MFN 08-124, Supplement 1

Subject: Supplemental Response to Portion of NRC Request for Additional Information Letter No. 116 Related to ESBWR Design Certification Application – RAI Number 21.6-65 S02

**Supplemental Response to Portion of NRC Request for
Additional Information Letter No. 116
Related to ESBWR Design Certification Application**

RAI Number 21.6-65 S02

Fig. 21.6-57-1 Generator Load Rejection With Total Turbine Bypass Failure

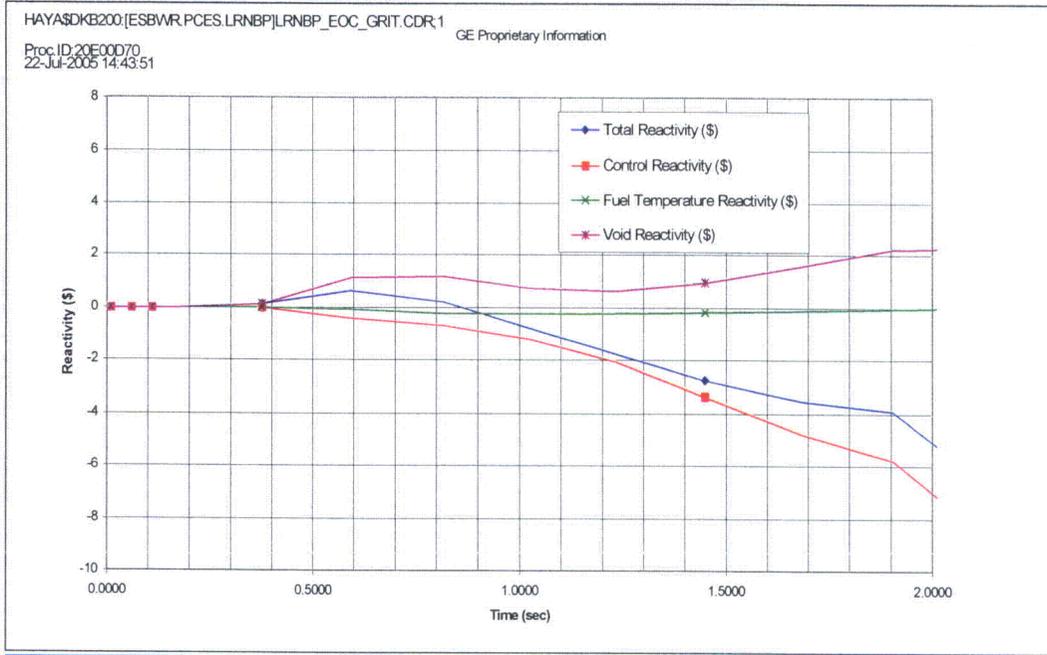
C. Provide a version of DCD Tier 2, Figure 15.3-5e magnifying the area between 0-2 seconds.

C. A 0-2 second plot corresponding to Fig. 15.3-5e of DCD Tier 2 is shown in Figure 21.6-57-1.

Figure 1. IICI Hot Bundle #2400 CPR

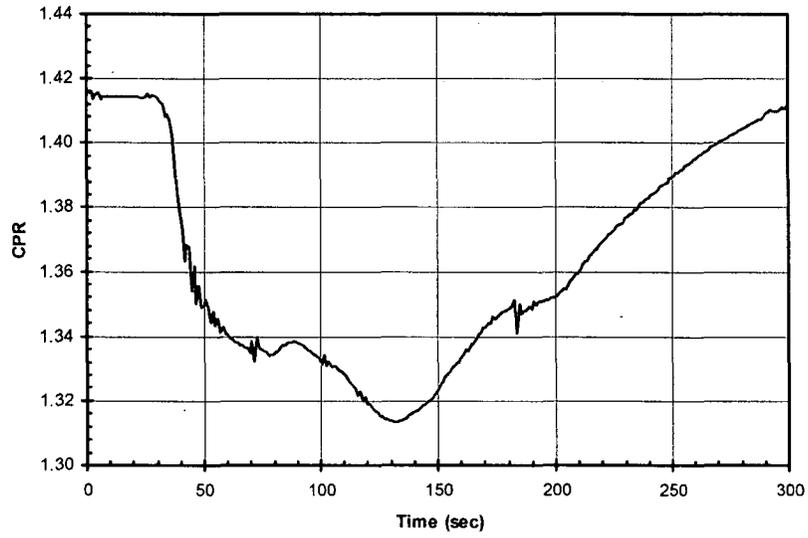
How are the channels selected for evaluating the maximum deltaCPR/ICPR that is used to determine the OLMCPR? Do you use the hot channel every time? Or do you take the maximum of all the channel groups? The staff is concerned for cold water injection events where although the Ring 3 channels (peripheral channels) do not have a hot channel, it is possible that these channel groups may experience the highest deltaCPR/ICPR.

The licensing criterion to be satisfied is that less than 0.1% of the fuel rods are expected to experience a boiling transition for the most severe AOO. Since the core MCPR always occurs in the hottest channels, the deltaCPR/ICPR of the hot channels are selected for the determination of OLMCPR.

TRACG calculation comparisons in Table 1 show that although the decrease in Δ CPR/ICPR of the peripheral channel (#341) in Ring 3 is greater than the hottest bundle (#2400) in Ring 2 for an IICI (Inadvertent Isolation Condenser Initiation) event in DCD Tier 2 Chapter 15 and in Ref. [2]; the Minimum Critical Power Ratio (MCPR) of the hot channel is much lower than the peripheral channel (Figures 1 and 2).

Therefore, the method for calculating OLMCPR is not affected by the fact that the Δ CPR/ICPR of the peripheral channel is higher than the interior channel in the cold water injection events, because the MCPR of the hot channel is substantially lower than that of the peripheral channel.
